A1 Birtley to Coal House Scheme Number: TR010031

Allerdene Burn – Channel Design Concept

**The A1 Birtley to Coal House
Development Consent Order 20[xx]**

Rule Number:	Rule 8(1)(c)(i)
Planning Inspectorate Scheme Reference	TR010031
Application Document Reference	Allerdene Burn – Channel Design Concept
Author:	A1 Birtley to Coal House Project Team, Highways England

Figure 2-1 - Location of the reach of the Allerdene Burn

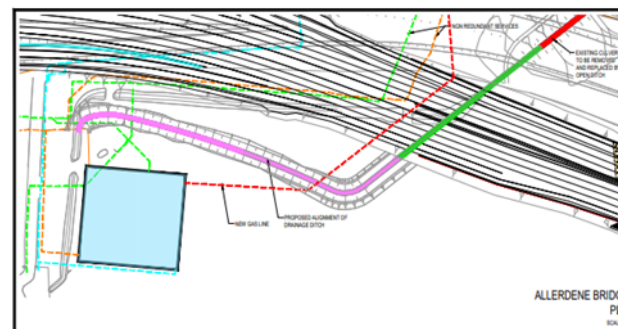
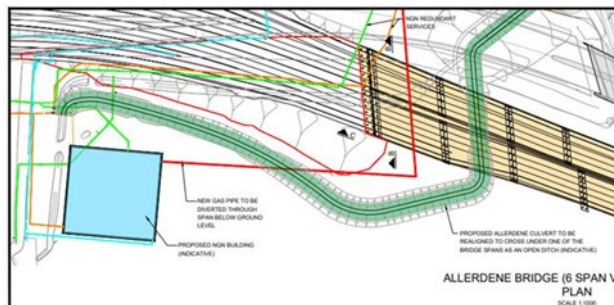
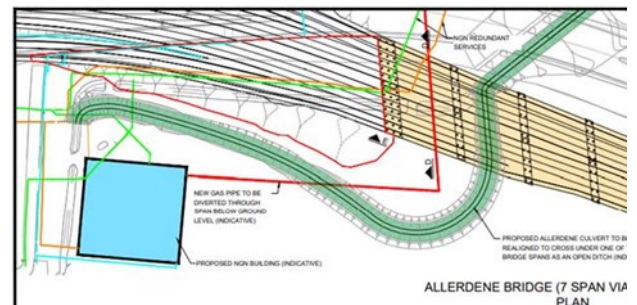
***Allerdene Burn:** The re-aligned and opened-up sections of the Allerdene Burn shown on the General Arrangement drawings (all 3 options) are over-engineered, with not enough variation in form or profile. It goes against good flood risk management principles with an engineered design and disconnect from its floodplain. The drawings should be modified to show a more naturalised channel that would conform with paragraph 5.2.3 of the WFD Assessment (Appendix 13.2). There is space to incorporate some areas of widened channel with slackened bank profiles, pools, and possibly some connected floodplain areas. Although the Environmental Statement suggests that naturalised features could be considered at detail design stage, a firm commitment to them should be made now, to avoid them being overlooked or value-engineered out at detail design stage.”*

- 3.1.1. The concept design of the naturalisation of the Allerdene Burn has been prepared for Allerdene viaduct three span option only given the similarities between the options: there is a minor difference in channel length between Allerdene embankment option and Allerdene three span viaduct option with the three span option being marginally longer; all other features remain the same. In relation to Allerdene viaduct option (6 and 7 span options), the channel dimensions remain similar, the channel lengths increase to obtain the required angle to cross beneath the viaduct between the supporting piers. It should also be noted that for Allerdene viaduct option (6 and 7 span options) and Allerdene three span viaduct option there is also the potential to incorporate a flood spillage area on the bank adjacent to the viaduct, subject to detailed design and scour risk.

Figure 3-2 – Channel Design Concept - Plan

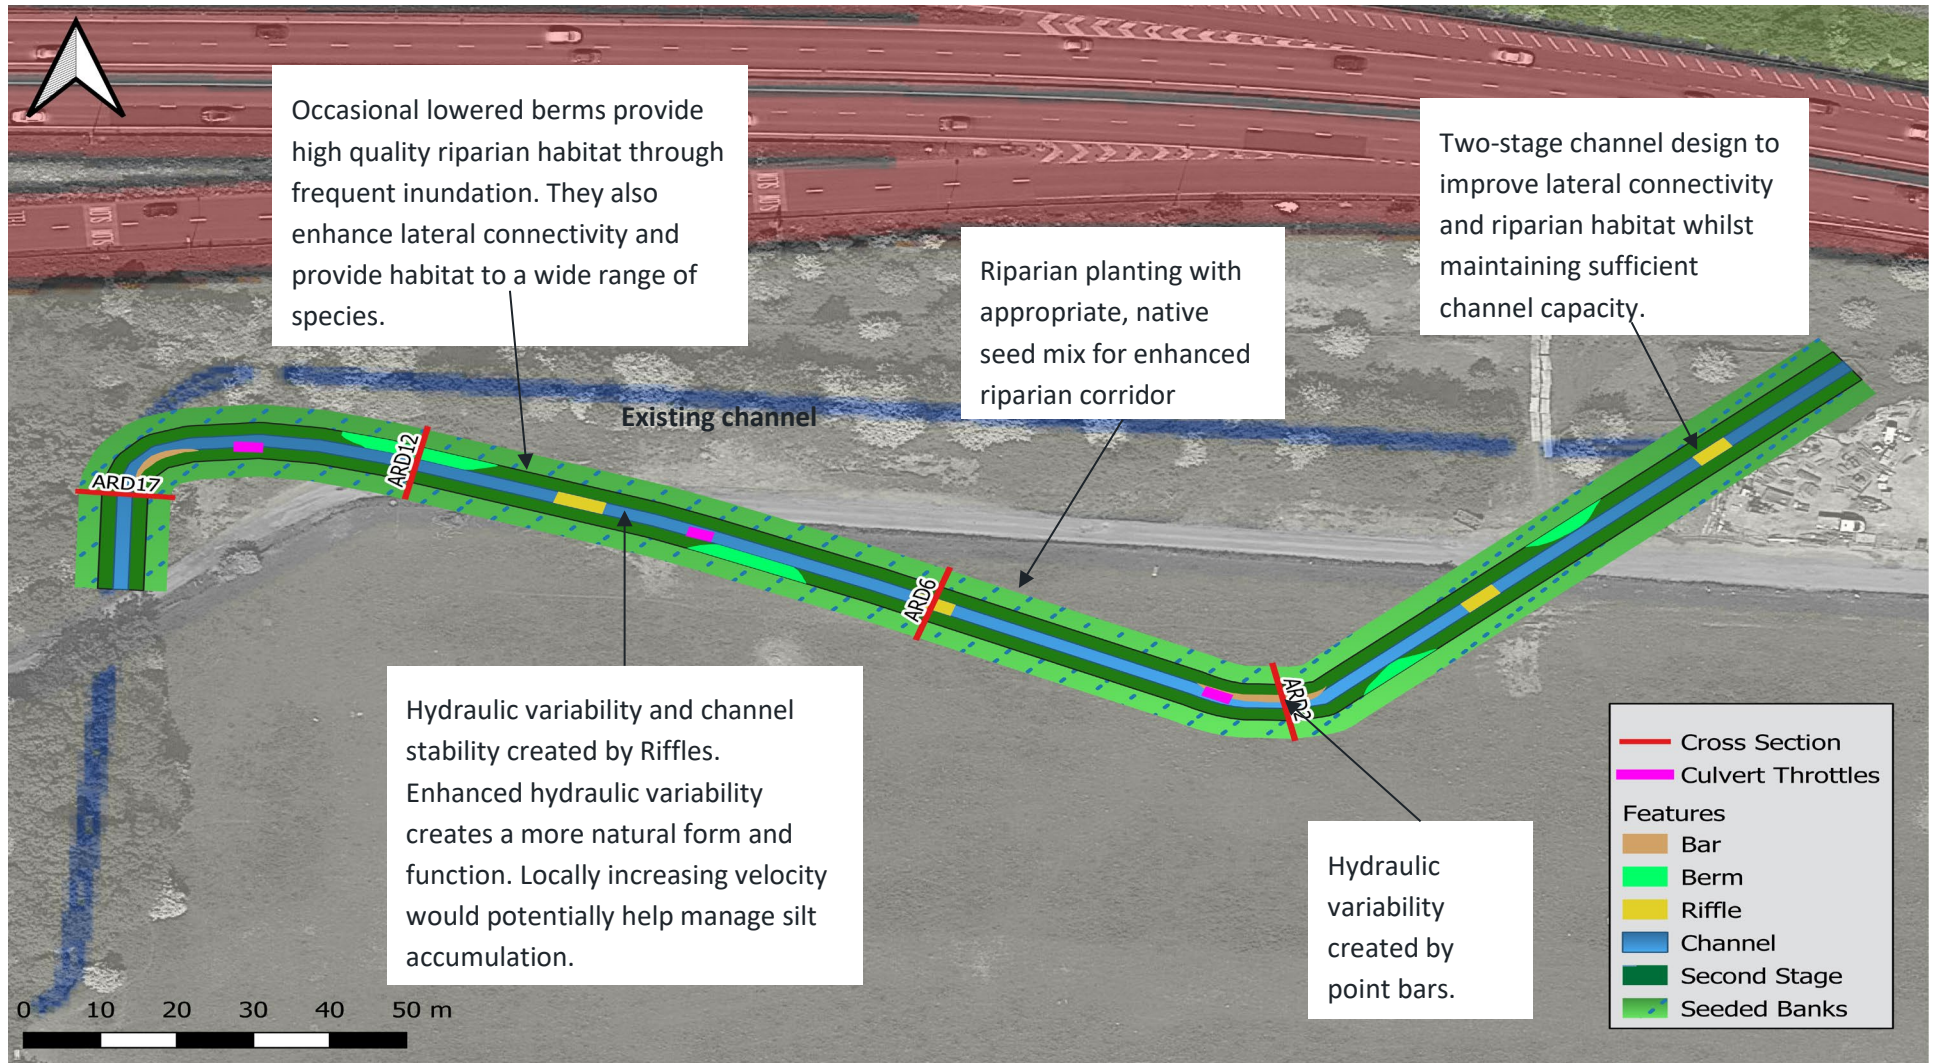
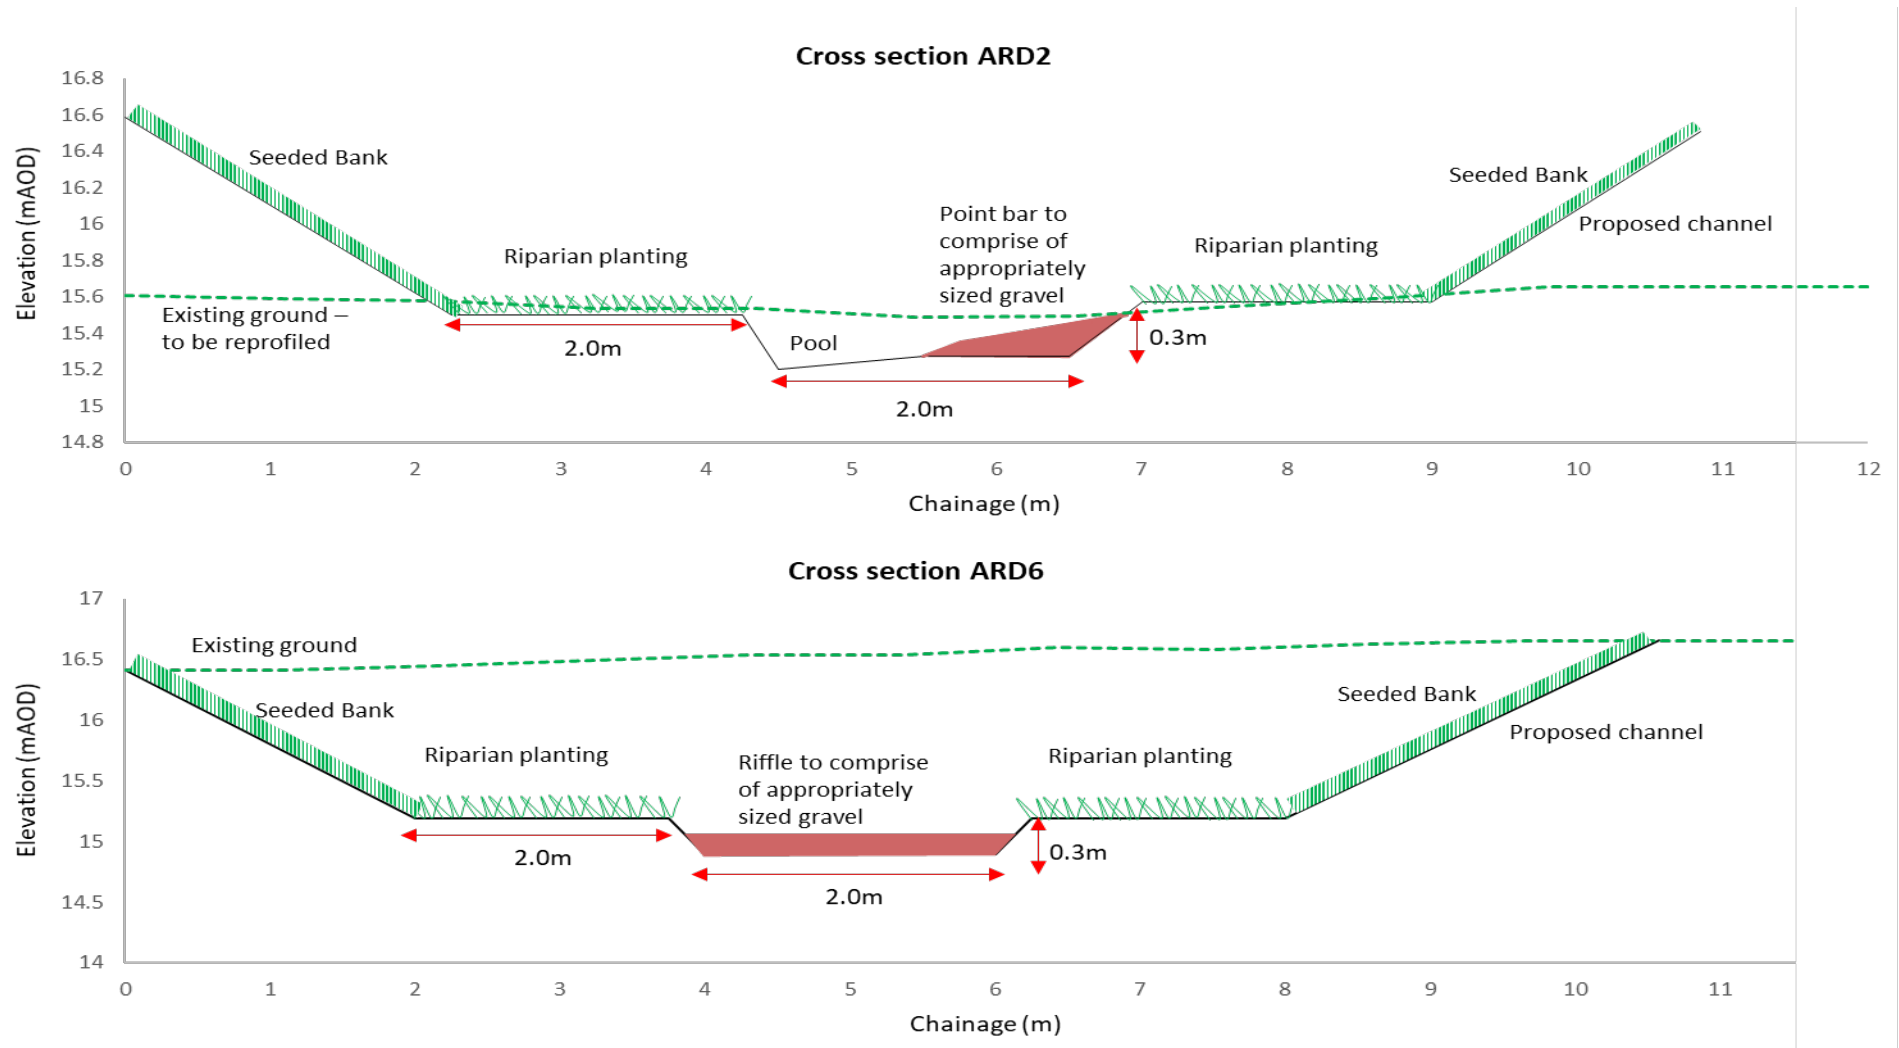
The new SUDS basin and realigned watercourse should be of naturalistic appearance with varied shape, multiple pools, varied side-slope gradients and channel profile, to create an attractive appearance and develop diverse habitats.

- 3.1.4. It is noted that ground re-profiling in the vicinity of Cross Section ARD2 (the location of the cross section is shown on **Figure 3-2** and the ground levels are shown in **Figure 3-3**) would need to be undertaken during the construction works to facilitate the construction of the channel, this is subject to detailed design.

3.1.6. The concept design is shown in both plan and cross section view **Figure 3-2** and **Figure 3-3** respectively.
